Project	<b>IEEE 802.16 Broadband Wireless Access Working Group</b> < <a href="http://ieee802.org/16">http://ieee802.org/16</a> >
Title	<b>Amendment to EAP Security Primitives in 14.2.2.1</b>
Date Submitted	<b>2007-03-0813</b>
Source(s)	Jung-Mo Moon, JeeHyeon Na, Mi-Young Yun, and Sangho Lee <a href="mailto:jhna@etri.re.kr">jhna@etri.re.kr</a> ETRI 161 Gajeong-dong, Yuseong-gu Daejeon 305-700 Korea
Re:	Contribution on comments to IEEE 802.16g/D8
Abstract	Re-definition of EAP primitives in 14.2.2.1
Purpose	Adoption
Notice	This document has been prepared to assist IEEE 802.16. It is offered as a basis for discussion and is not binding on the contributing individual(s) or organization(s). The material in this document is subject to change in form and content after further study. The contributor(s) reserve(s) the right to add, amend or withdraw material contained herein.
Release	The contributor grants a free, irrevocable license to the IEEE to incorporate text contained in this contribution, and any modifications thereof, in the creation of an IEEE Standards publication; to copyright in the IEEE's name any IEEE Standards publication even though it may include portions of this contributi

Figure 473 – EAP based Authentication Procedure

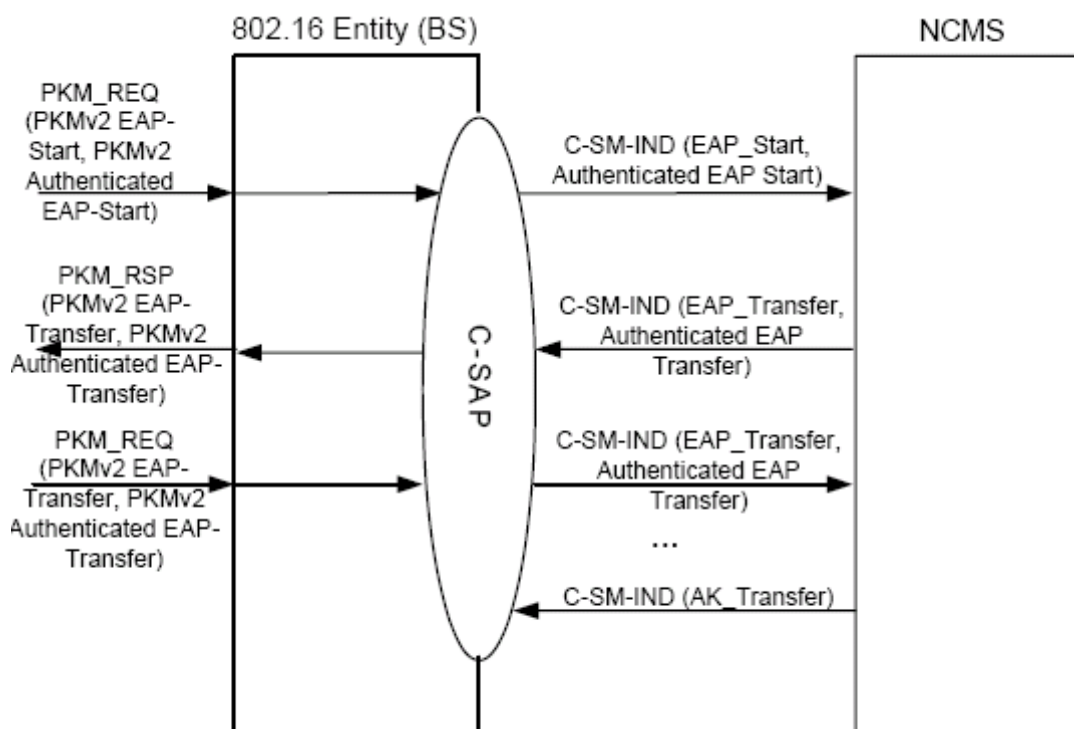
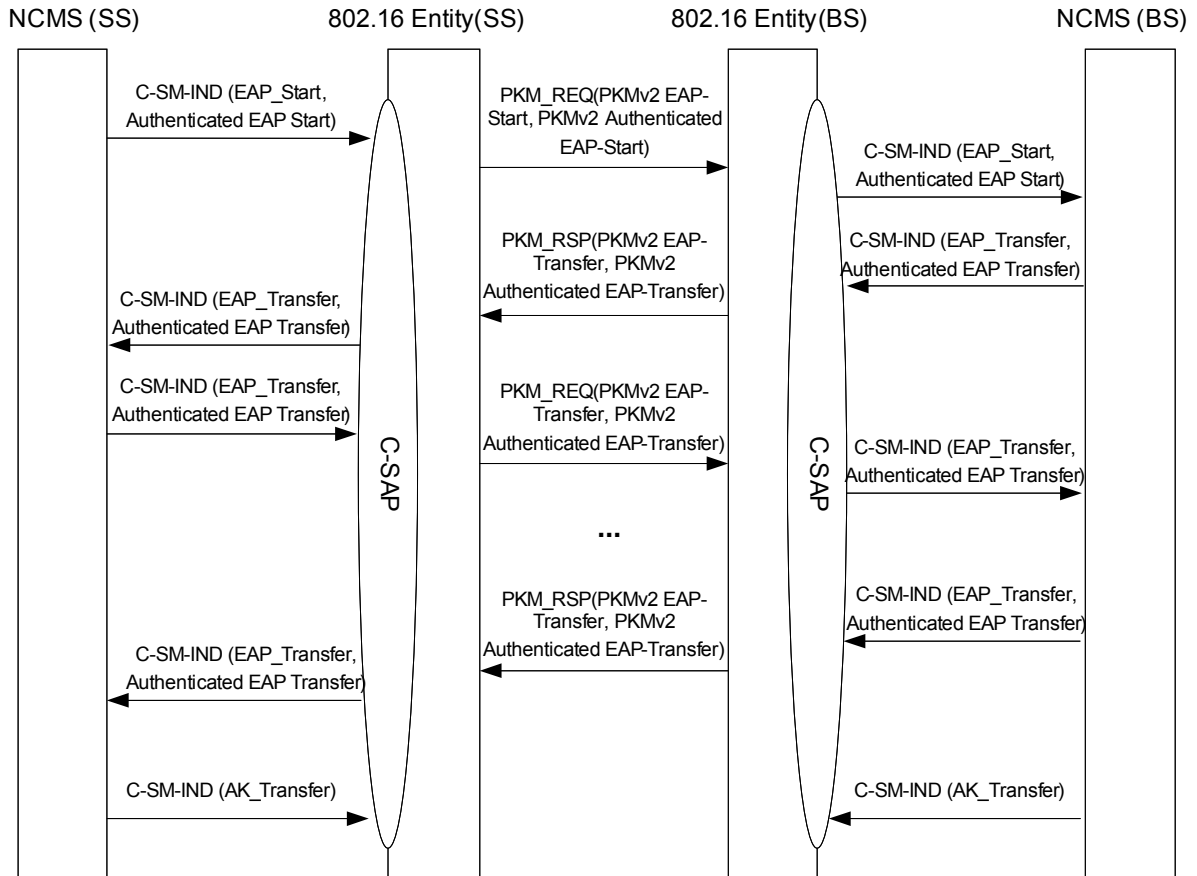
1. Modification of figure 473 to illustrate EAP-based security primitives on SS side.
2. Modification of each subsection to clarify and describe on each side (SS and BS side)

Figure 473 shows EAP-based authentication procedures between an BS-802.16 entity and an NCMS on SS and BS sides and an AAA Services entity in NCMS as follows:
